# Product Support Bulletin

CPGF - S - 00000403 - 0

**Title:** Safety Campaign #2954 - Rental Hinge Replacement

**Model(s)** C60 D6R, C100 D6R, C200 D6R, C300 D6R, C150 D2RE, C200 D2RE, C275 D2RE

**Replacing Hinges**

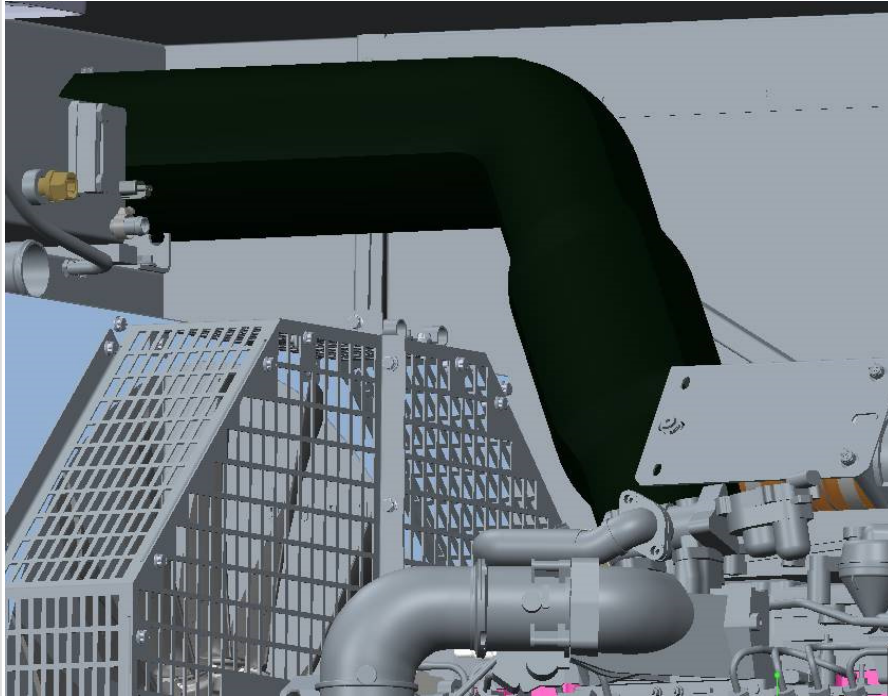
Some Rental Generators that were built in 2016 were equipped with composite hinges. If the composite hinges crack, they may fail to maintain attachment of the door.

If the door becomes detached during transport, it may fall into the roadway, increasing the risk of a motor vehicle accident. If detachment occurs while stationary, it may result in personal injury. This Safety Campaign addresses these conditions by replacing all door hinges and associated mounting hardware on the generator set with door hinges of a different design.

While removing hinges, the door should be supported as to not fall. We recommend utilizing a crane or hoist to hold the door while performing the work. If a crane/hoist is not available, another technician is authorized to support the door while hinges are replaced.

1. While the end of the door is supported, remove the top hinge from the door
2. Next, remove the top hinge from the enclosure

3. Install the new door hinge on the enclosure using new hardware.
4. Next, install the new door hinge on to the door.
5. Once the first hinge is installed, repeat the same steps on the bottom hinge
6. If the door has three hinges, repeat the same steps on the middle hinge
7. Once all hinges are installed, adjust panel gap as needed ensuring that the door does not rub on the enclosure
8. Torque the hinge hardware to **26 Nm**

### **C300 D6R**

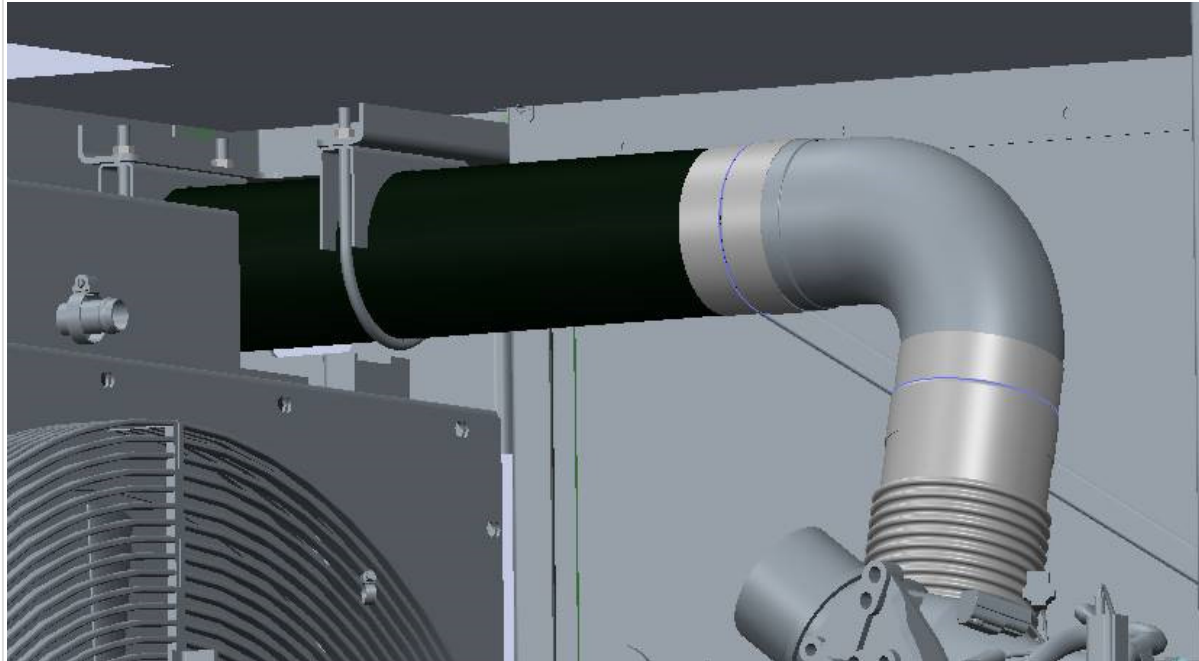
The C300 D6R generator set has a potential interference on the top hinge of the right side engine door. This may require components to be removed to gain access.

### **C60, C80, C100 D6R**

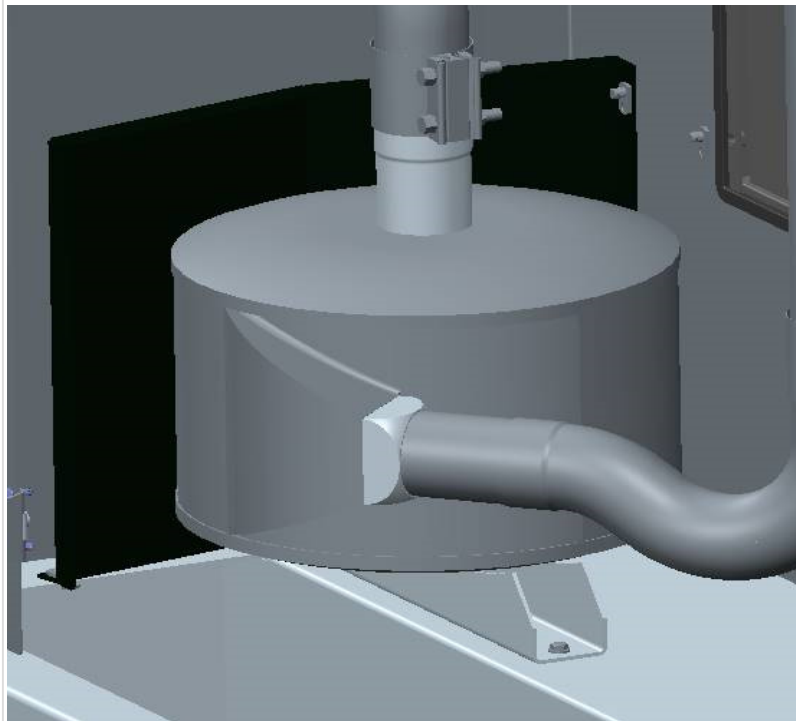
The C60-C100 D6R generator sets have a potential interference on the right side engine door. The muffler heat shield in the exhaust compartment may interfere with your ability to access the hinge hardware. The heat shield is connected with 4 bolts, two in the engine compartment and two under the heat shield. Once the heat shield bolts have been removed, the heat shield can be slid forward to gain access to the hinge hardware. Torque heat shield hardware to **27 Nm**

### **C200 D6R, C150 D2RE, and C200 D2RE**

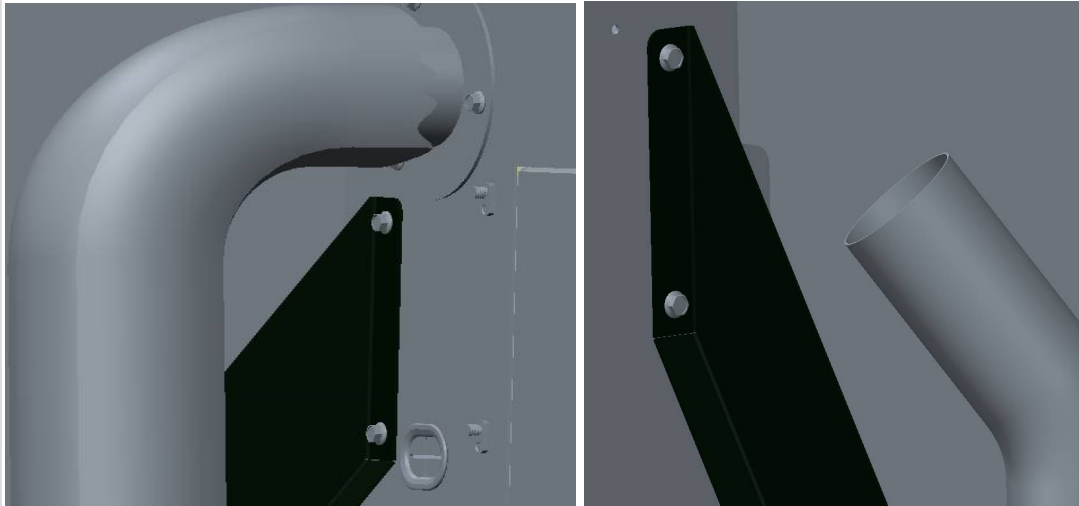
The C150 and C200 generator sets have a potential interference in the exhaust compartment. There are two bulkhead supports that are structural support for the radiator. If there is an interference, unbolt from bulkhead only and flex the component out of the way. Ensure to only remove one from the bulkhead at a time to provide adequate support for the radiator. Torque hardware on the bulkhead to **42 Nm**

### **Door Striker Plates**

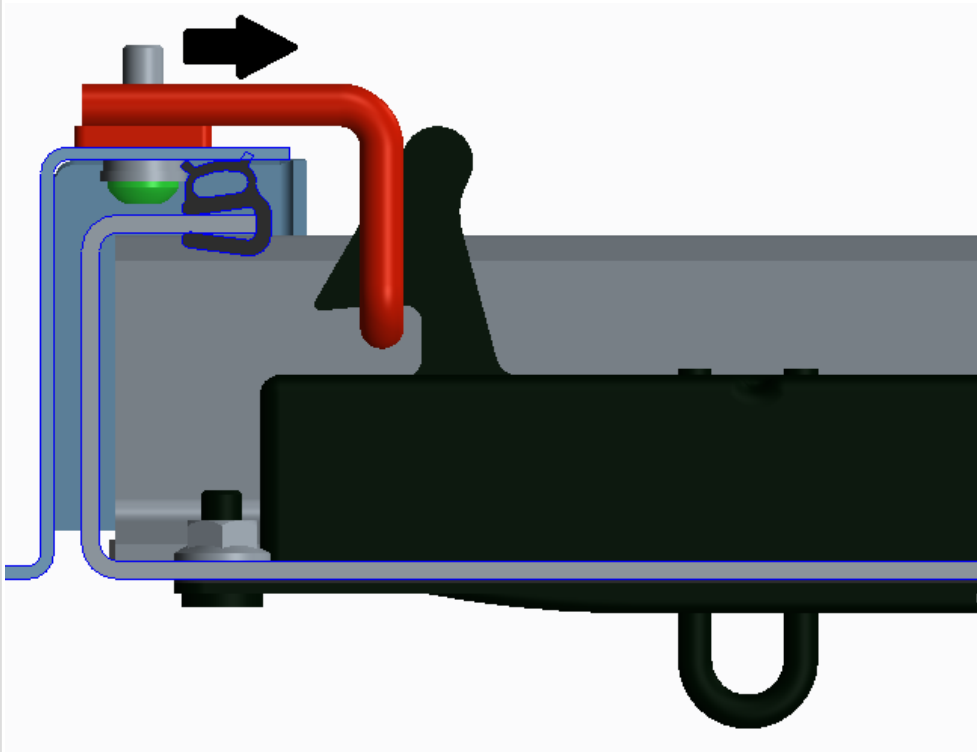
The replacement of the hinges may result in a tolerance stack up on the slam latch striker plate. Included in the kit is an adjustable striker plate. Striker plates are replaceable on the engine doors (all units) and the generator door (all units except C300 D6R and C275 D2RE)

1. Remove existing striker plate
2. Install new striker with the hoop moved to the position closest to the hinges of the same door. Tighten and
3. Check actuation of the slam latch by closing the door and feeling for any interference in the mechanism.
4. Then install a padlock on the slam latch and then pull on the "locked" door handle. If the door does not open while locked and there is no interference in the mechanism, the striker is in the correct position.
5. If there is interference in the mechanism or the door opens on the pull test, adjust the position of the striker plate until satisfactory.
6. Torque the striker plate hardware to **8 Nm**
